ATTACHMENT 1

HADDAM NECK PLANT

ADEQUACY OF STATION ELECTRIC DISTRIBUTION SYSTEM VOLTAGES

AUXILIARY BUS SYSTEM

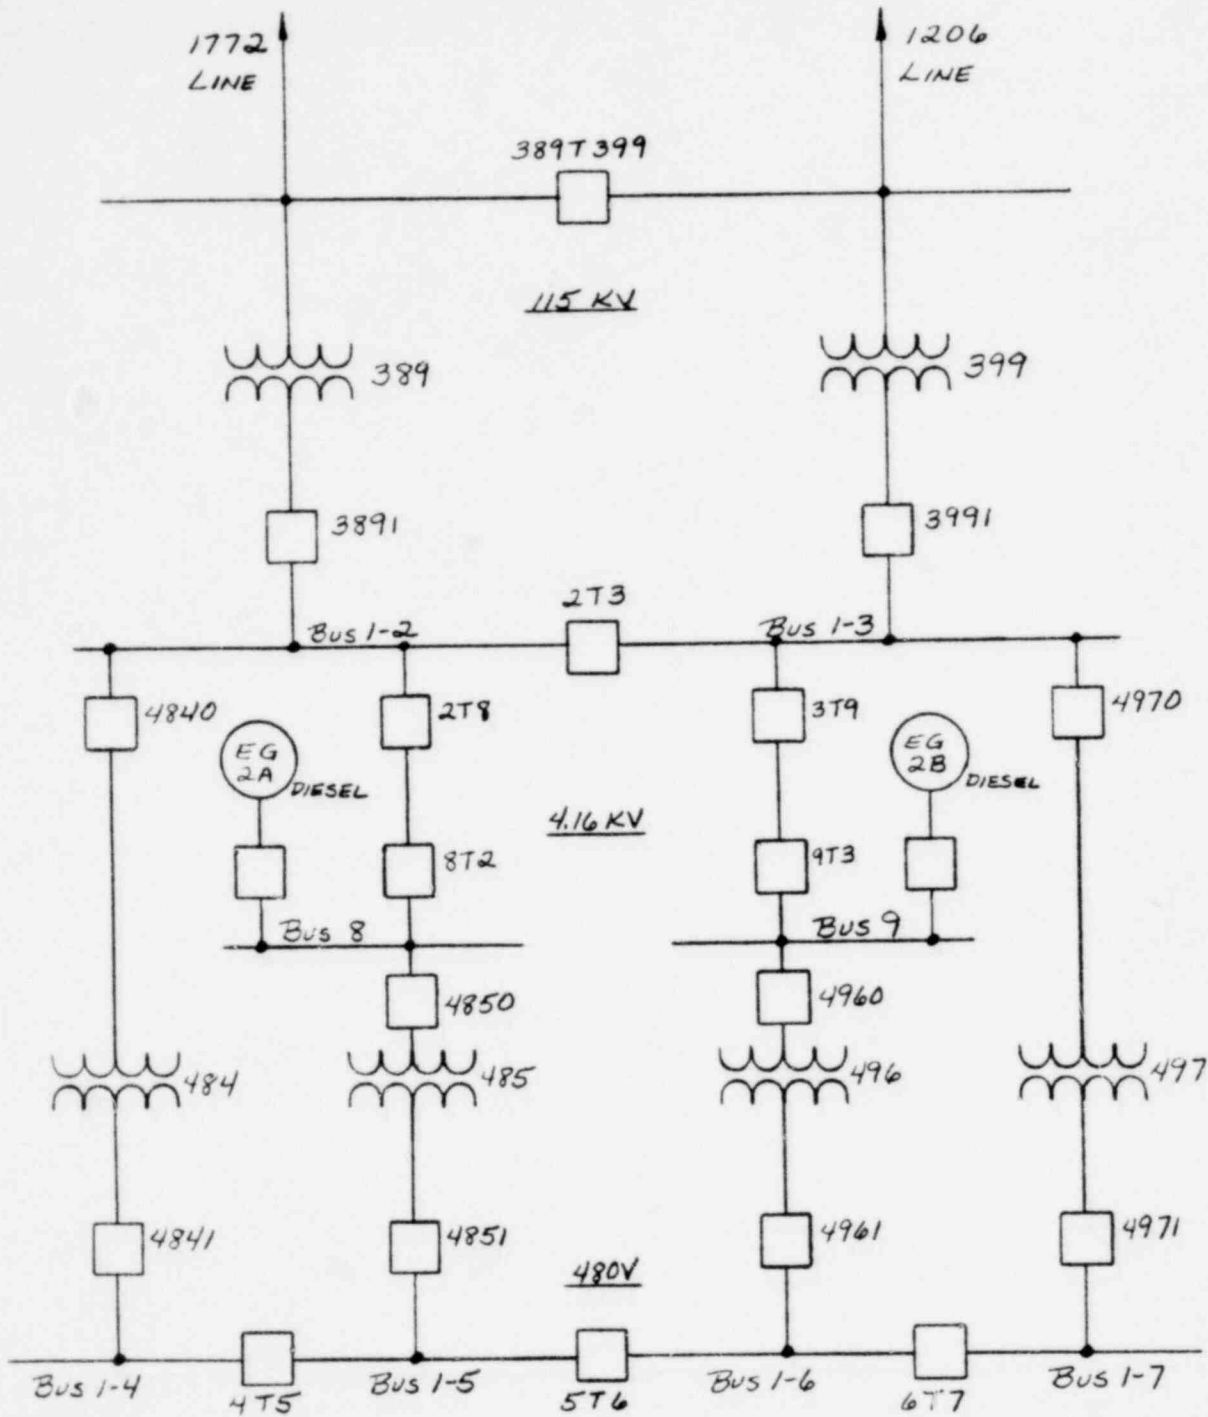
You are requested to review the electric power systems of your nuclear station to determine if there are any events or conditions which could result in the simultaneous or consequential loss of both required circuits to the offsite network to determine if any potential exists for violation of GDC-17 in this regard.

Our review of the electric power systems, which are shown on the attached sketch, has revealed two events, each of which could result in the simultaneous loss of both required circuits from the offsite network.

- 1) The failure of 4,160 V tie breaker 2T3, which for the purpose of GDC-17 review is considered part of the onsite electric power system, will cause the loss of both circuits from the offsite network as a consequence of automatically clearing buses 1-2 and 1-3 to isolate the fault. This failure does not cause loss of the redundant onsite power supplies nor does it prevent these power sources from supplying all segments of the redundant safety-related onsite distribution systems. We have, therefore, concluded that no potential violation of GDC-17 exists for this event since the single failure of breaker 2T3 does not affect either of the redundant onsite electric power systems.

- 2) In the unlikely event that 115-KV breaker 389T399, which is part of the offsite power system, were to fail, it would cause automatic tripping of 115-KV lines 1206 and 1772 which constitute the two offsite circuits to the plant. The design of breaker 389T399 control and protection systems, incorporates separate and independent equipment which is powered from redundant 125V D.C. supplies. The object of this design feature is to minimize the possibility of breaker failure to trip occurring as a result of a control or protective relay malfunction. We have, therefore, concluded that this event does not violate GDC-17 since we consider the design of breaker 389T399 minimizes to the extent practical the likelihood of its failure and a switchyard common to both offsite power circuits is permissible.
